BELLEFONTE COMBINED LICENSE APPLICATION – RESPONSE TO REQUEST FOR  
ADDITIONAL INFORMATION – SHORT TERM ATMOSPHERIC DISPERSION ESTIMATES  
FOR ACCIDENT RELEASES

Reference: Letter from Joseph Sebrosky (NRC) to Andrea L. Sterdis (TVA), Request for  
Additional Information Letter No. 119 Related to SRP Section 02.03.04 for the  
Bellefonte Units 3 and 4 Combined License Application, dated August 08, 2008

Subject: Short Term Atmospheric Dispersion Estimates for Accident Releases in the Final Safety  
Analysis Report

**NRC RAI NUMBER: 02.03.04-05**

Figure 02.03.04-05A

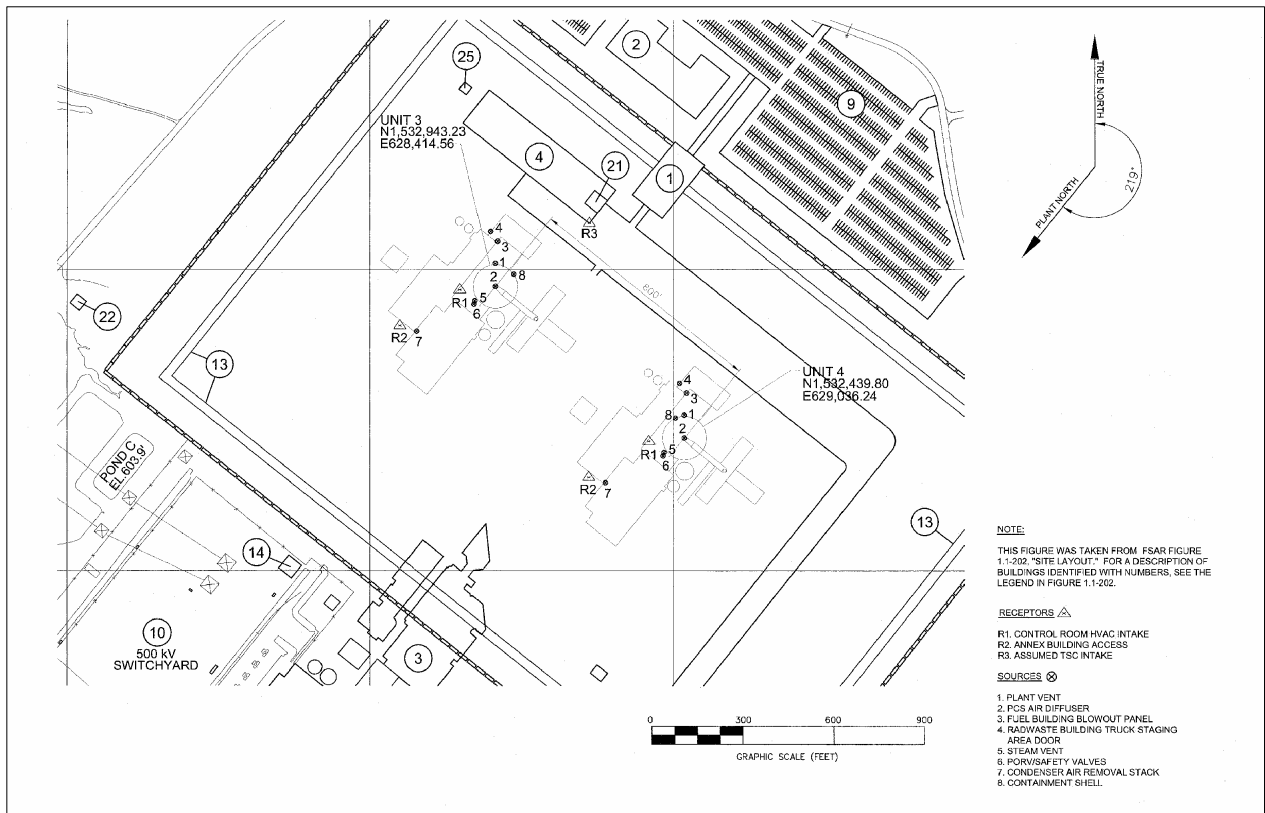
The applicant has taken a departure in FSAR Chapter 18, Human Factors Engineering, in that the Bellefonte TSC is not located in the control building as identified in the AP1000 DCD (Departure No. BNL DEP 18.8-1). Provide a description of the methodology, inputs, assumptions, and calculated atmospheric dispersion factors ( $\chi/Q$  values) for releases from the Plant Vent, PCS Air Diffuser, Fuel Building Blowout Panel, Fuel Building Rail Bay Door, Steam Vent, PORV/Safety Valves, Condenser Air Removal Stack, and Containment Shell to the Technical Support Center (TSC). Information provided should be analogous to that provided for releases to the control room and include drawings to show relevant information graphically. Consider providing the computer input files as part of the response.

The TSC is located in the east end of the BLN maintenance building as shown in the Site Layout, FSAR Figure 1.1-202. Exact locations of the receptors of interest, the TSC HVAC intake and facility entrance, are not yet final; therefore, they are conservatively assumed to be located on the wall of the new maintenance building closest to Unit 3 at an elevation of 1.5 m (see Figure 02.03.04-05A below).

The AP1000 release locations are given on DCD Figure 15A-1 and Table 15A-7. When these locations are transposed onto the BLN Site Layout as shown in Figure 02.03.04-05A, it can be seen that the general direction from the assumed TSC receptors to the majority of the release locations is very similar. The release locations that are closest to the TSC are the containment shell, the plant vent, the fuel building blowout panel, and the radwaste building truck staging area door. According to the AP1000 DCD
